AMENDMENT OF SOLICITATION/MODIFICATION OF CONTRACT			1. Contract Number		Page of Pages	
					1	5
2. Amendment/Modification Number		3. Effective Date		4. Requisition/Purchase Request No.		5. Solicitation Caption
GF-2026-B-0016_006		See item 16C				Building 43 Roof Replacement

14. Description of amendment/modification (Organized by UCF Section headings, including solicitation/contract subject matter where feasible.)						
Solicitation No. GF-2026-B-0016 for Building 43 Roof Replacement is hereby amended as follows:

**Questions & Answers**  
**GF-2026-T-0016, Bldg. 43 Roof Replacement**

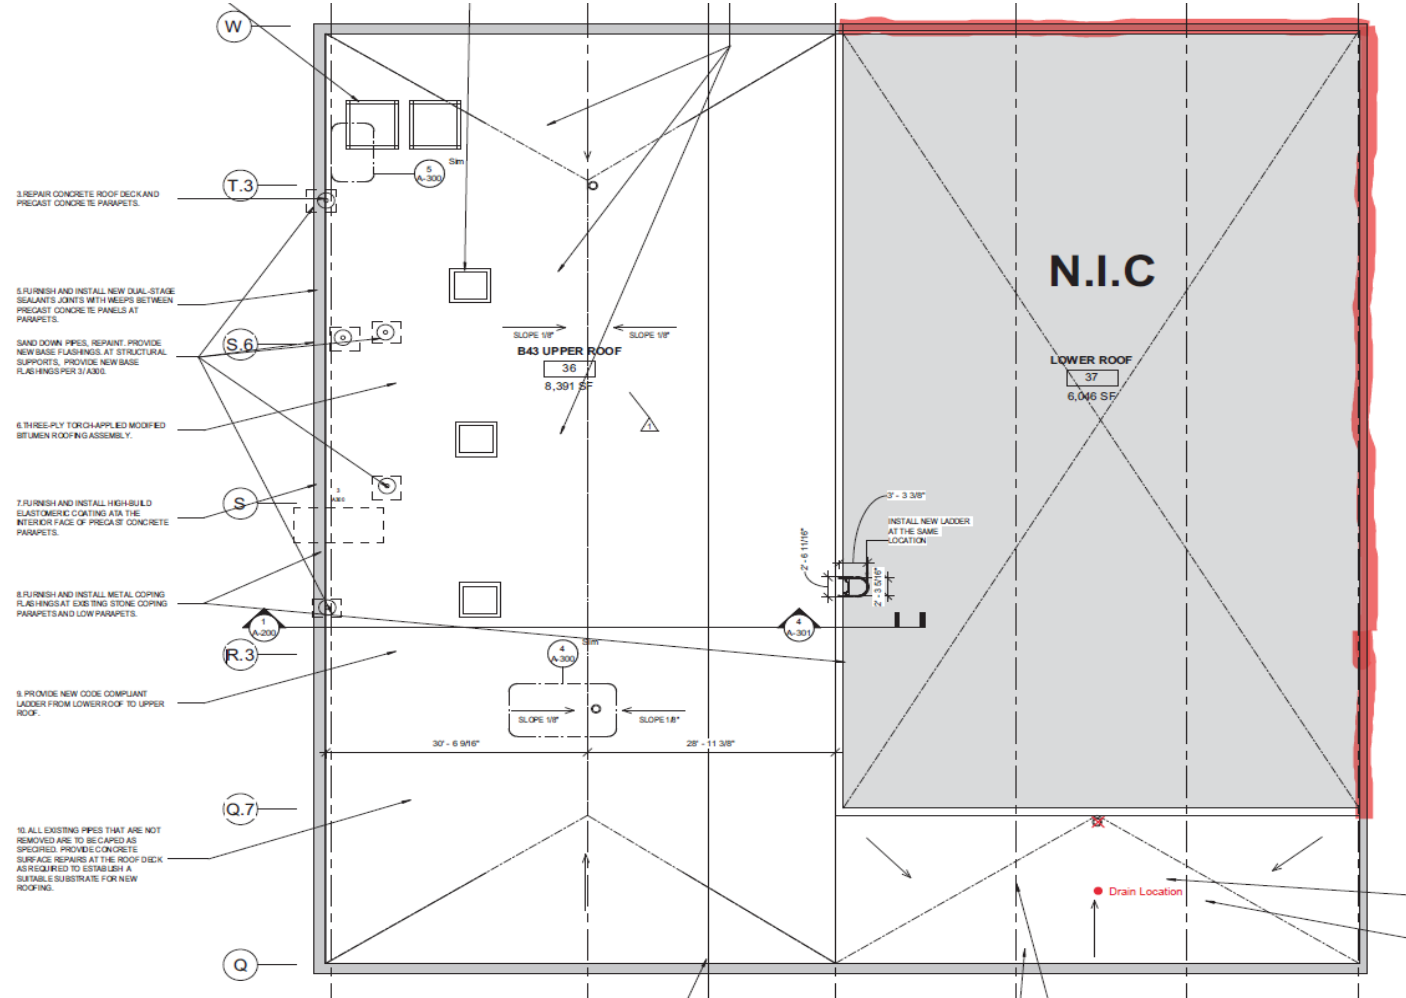
18	(A-102) Will the coping continue around the entire perimeter including the area highlighted below?	No, please see the image below - the red/orange area is not in contract - no parapet walls, backer rods, sealants etc. work.
19	Where is the staging area for the dumpsters, materials storage? Can we block some of the space at the loading dock?	Staging for a dumpster will be on the parking lot surface near the entry to Building 42. Materials storage will be on the 43A level plaza next to the building. Contractor to fence the storage area.
20	Note 1 and 8 on drawing E101 indicate to remove and reinstall the existing disconnect switches for the exhaust fans after the new curbs are replaced. Those existing disconnect switches are very old. Please confirm that those existing disconnect switches can be reused and still function, and there are proper electrical power feeders to those switches/exhaust fans	Disregard fan schedule. The existing fan units identified are to remain. However, the fan units electric motors and disconnects for the fan units identified in key note #4 on sheet M-101 are to be replaced in kind.
